INDIANA DEPARTMENT OF TRANSPORTATION

APPROVED MINUTES

June 16, 2016 Standards Committee Meeting

RE: Minutes from the June 16, 2016 Standards Committee Meeting

UNDERDRAIN DRAWING INDEX
AND GENERAL NOTES
SEPTEMBER 2017

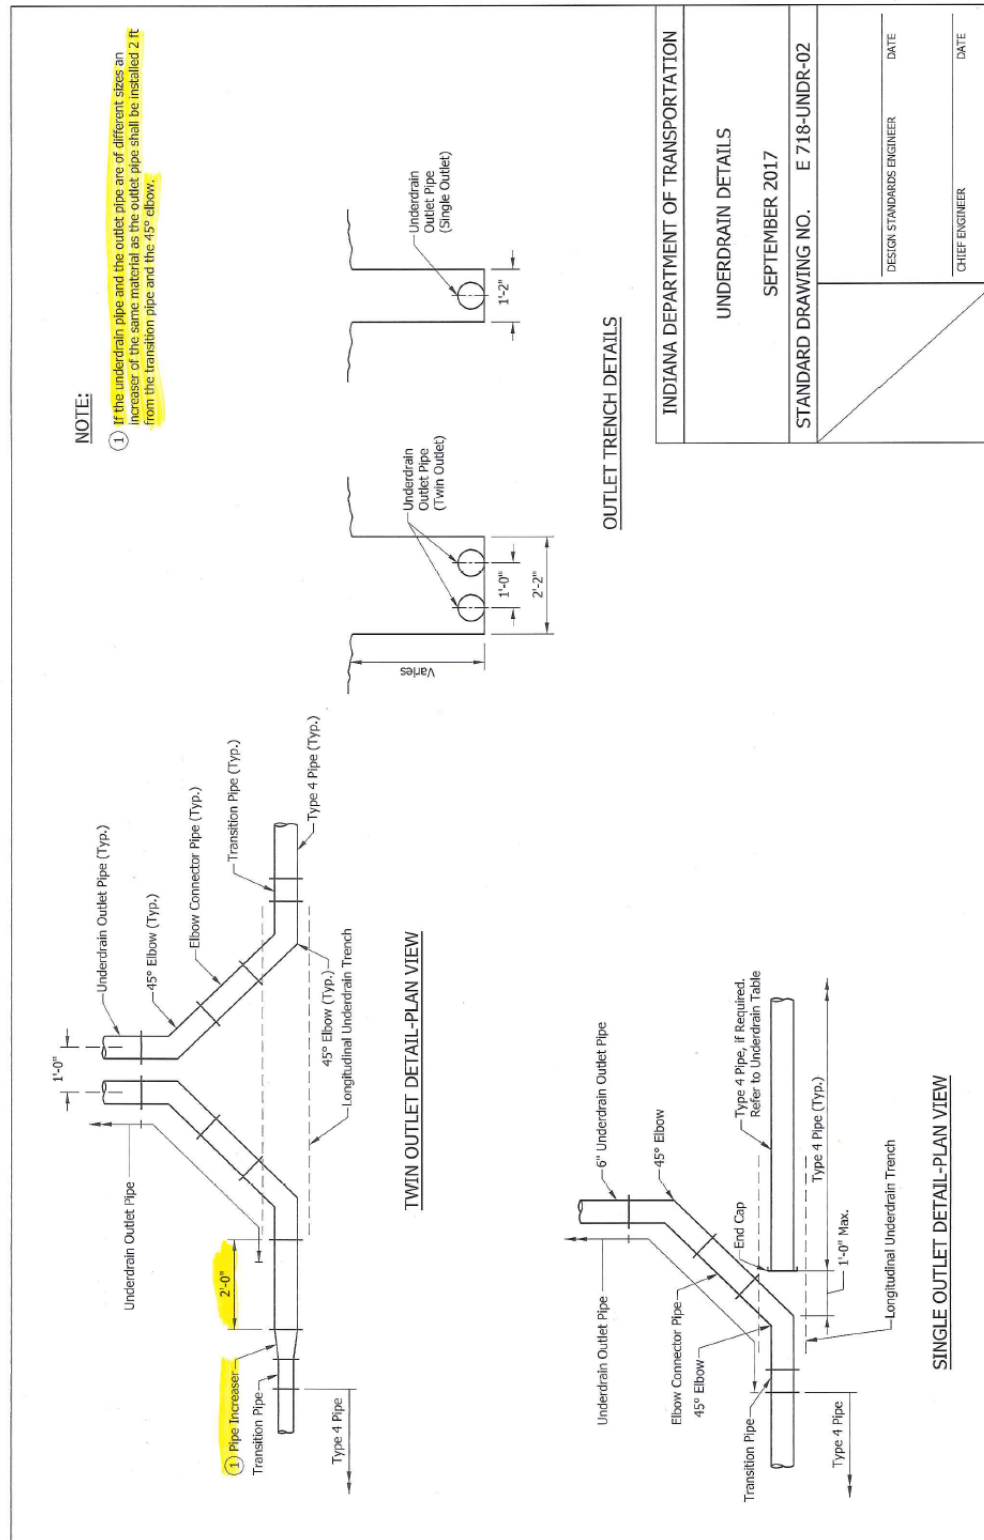
SECTION 718, BEGIN LINE 71, DELETE AND INSERT AS FOLLOWS:

(d) Tether Bracket

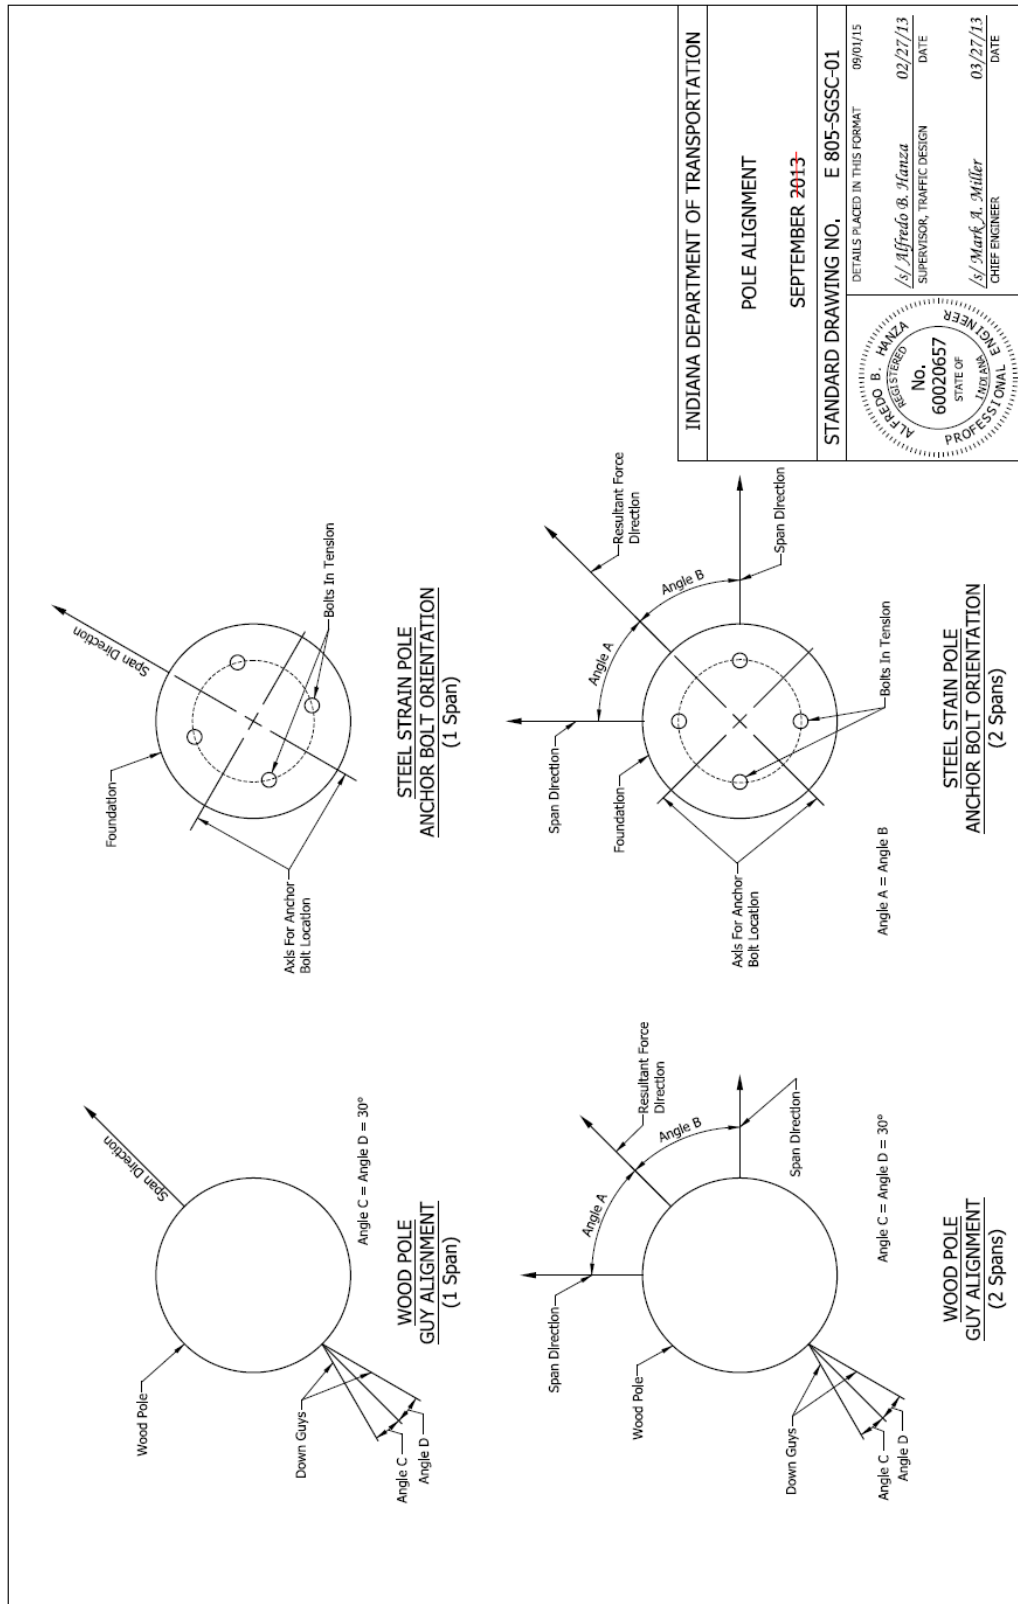
The tether bracket shall attach to a ~~1/8 in. to~~ 1/4 in. ~~messenger cable~~ *tether* and prevent the bottom of the head from moving side-to-side on the ~~cable-tether~~. Where backplates are installed on the signal heads, the tether bracket shall be of the proper length for the backplate so that the cable is mounted below the bottom of the backplate to avoid interference with head alignment and damage to the backplate. *Three bolts, nuts, and washers, shall be used to secure the tether bracket to a three-section or four-section signal head. A wire rope clamp in accordance with 922.10(e)4c, shall be used to secure the tether bracket to the tether and the tether bracket shall have predrilled 1/2 in. diameter holes. In lieu of the wire rope clamp and 1/2 in. diameter holes, a beveled tether plate that completely fills in the extruded portion of the tether bracket may be used to secure the tether bracket to the tether. The tether bracket shall not extend more than 2 in. below the tether.*
